Subject: UniStar Nuclear Energy, NRC Docket No. 52-016
Response to Request for Additional Information for the
Calvert Cliffs Nuclear Power Plant, Unit 3,
RAI 218, Stability of Subsurface Materials and Foundations
Questions 02.05.04-05 and 02.05.04-13

**RAI No. 218, Stability of Subsurface Materials and Foundations,
Questions 02.05.04-05, and 02.05.04-13**

Calvert Cliffs Nuclear Power Plant Unit 3

Figure 1: Shear Wave Velocity and Strength of Concrete Material (Cho et. al.)

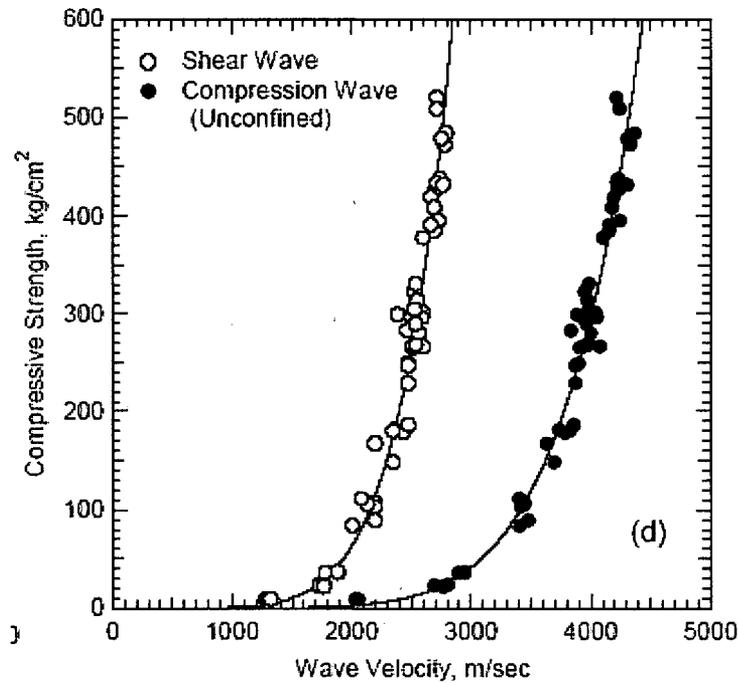
Section 2.5.4.5.2 indicates that the excavations will be backfilled with compacted structural fill to the foundation level or, if necessary, lean concrete will be placed as a leveling mat. Since the lean concrete will be used directly underneath the Category 1 structures, please describe the properties of the concrete (such as strength and shear wave velocity), and the criteria that will be used to determine where the lean concrete leveling mat should be used. In addition, describe the controls to ensure that the concrete fill can provide adequate support of both static and dynamic loadings for the foundation.

Correlation is provided between wave velocity and concrete compressive strength (Cho et. al.). Figure 1 defines the relationship among shear wave velocity, compression wave velocity, and compressive strength of concrete. From this figure, for 2,500 psi (about 175 kg/cm^2) strength concrete, shear wave velocity of about 2,300-2,400 m/sec (about 7,500-7,900 ft/sec) is shown.

The two approaches described above indicate V_s values in the range of about 6,000-8,000 ft/sec for 2,500 psi concrete. Therefore, $V_s = 7,000 \text{ ft/sec}$ is used for concrete fill.

Figure 2.5-212 – {Settlement Monitoring Instrumentation in the Power Block Area}

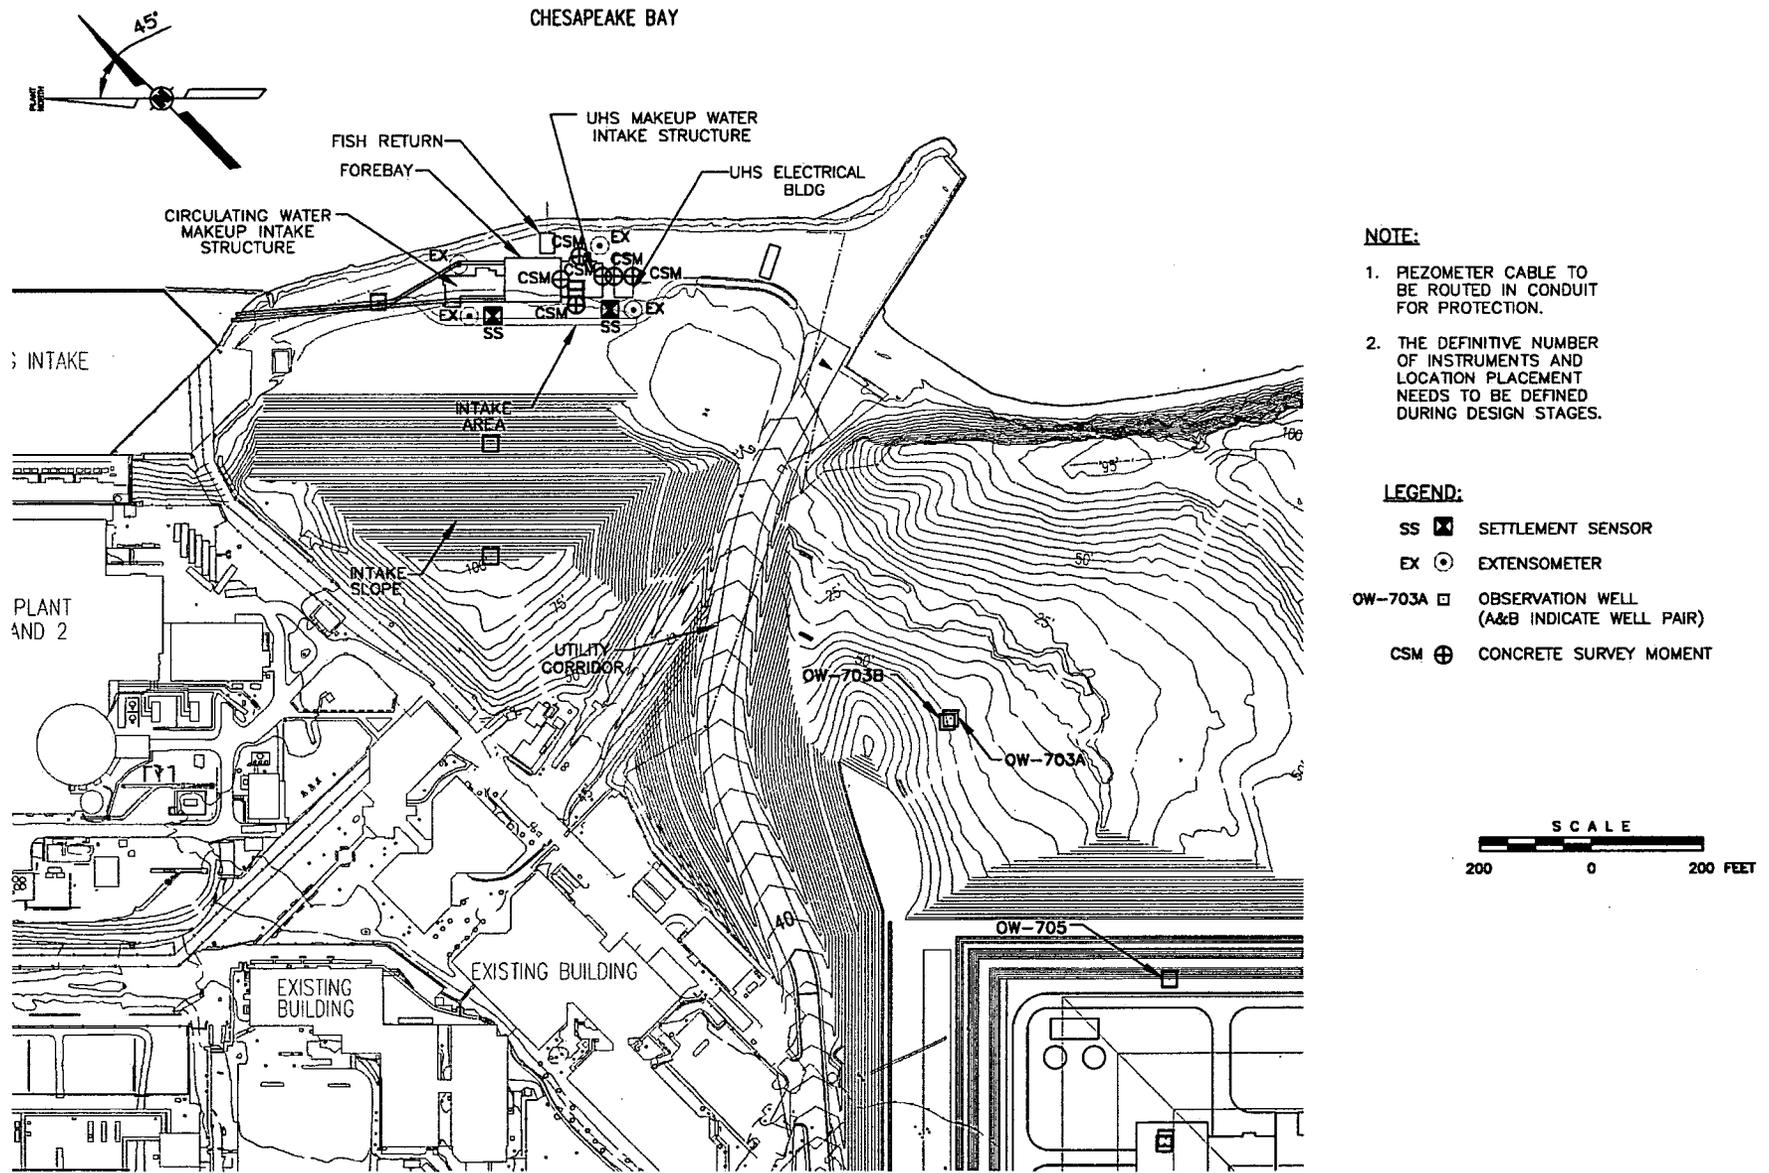
Sections 2.5.4.5.4 and 2.5.4.10.2.2 indicate that monitoring program specifications for foundation rebound (heave) and settlement will be developed during the detailed design stage of the project. Since foundation rebound and settlement are expected at the site, and estimated differential settlement of the reactor building will exceed the standard design criterion, please provide a detailed description of the monitoring program including all basic elements, such as the settlement monitoring bench marks, locations of instruments, monitoring and recording frequency, and evaluation of the magnitude of rebound and settlement during and after excavation and construction.

The instrumentation plan for the Powerblock Area of the site will consist of horizontal settlement sensors, Vibrating Wire (VW) piezometers, surface monuments, concrete anchored monuments, extensometers and one accelerometer. The definitive number of instruments needs to be established during design stages of the monitoring system. The tentative locations of the instruments are shown on Figure 2.5-212.

Tested and calibrated settlement sensors will be used to monitor settlement and heave within the excavation footprint. Settlement sensors will be installed at the bottom of the proposed foundation (bench mark El. 40) before the excavation of the Powerblock Area is started. The sensors will be placed at the approximate locations shown on Figure 2.5-212 and the required cables will be routed away from the fill area.

Figure 2.5-212 shows a tentative distribution and placement of VW piezometers to be installed around the Perimeter of the Powerblock Area. The VW piezometers will be used to measure ground water elevations and associated changes in pore pressure during dewatering, excavation, structural backfill placement, and plant construction.

After the structural backfill has been placed to the final grade, Surface Monuments (SM), bench mark El. 80 shall be placed on the surface of the backfill at approximate locations shown on Figure 2.5-212. The monuments shall consist of a one foot diameter concrete cylinders placed a minimum of three feet below final grade and be fitted with a brass dome cap with a point for survey use.
